SS 715-WST 2022 49X Transmission Cooler Line Plumbing Fitting

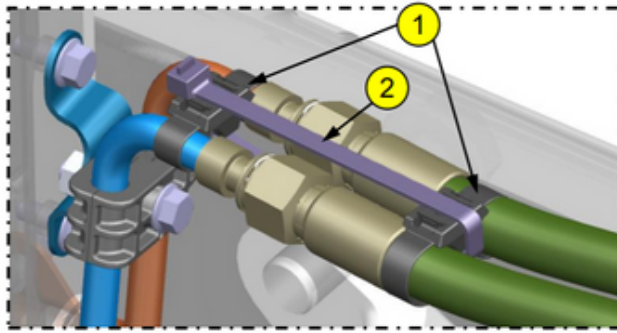
Transmission cooler line plumbing fitting connections at the radiator may have relative movement between rail and radiator allowing fittings to become loose and leak.

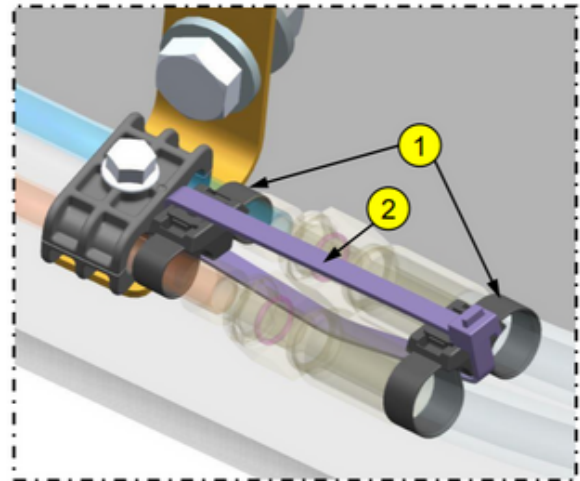
Install parts below to existing trans cooler plumbing lines as shown (fwd and aft locations shown below):

TYCDCT110HIR Tie cable dual, .375 to 2.25 quantity(4)

23-09796-629 Clamp-cable tie,15", 0-4 bundle quantity(2)

PULL ITEM #2 SNUG TO PROVIDE
SECONDARY RESTRAINT ACROSS
QUICK-CONNECT JOINTS.
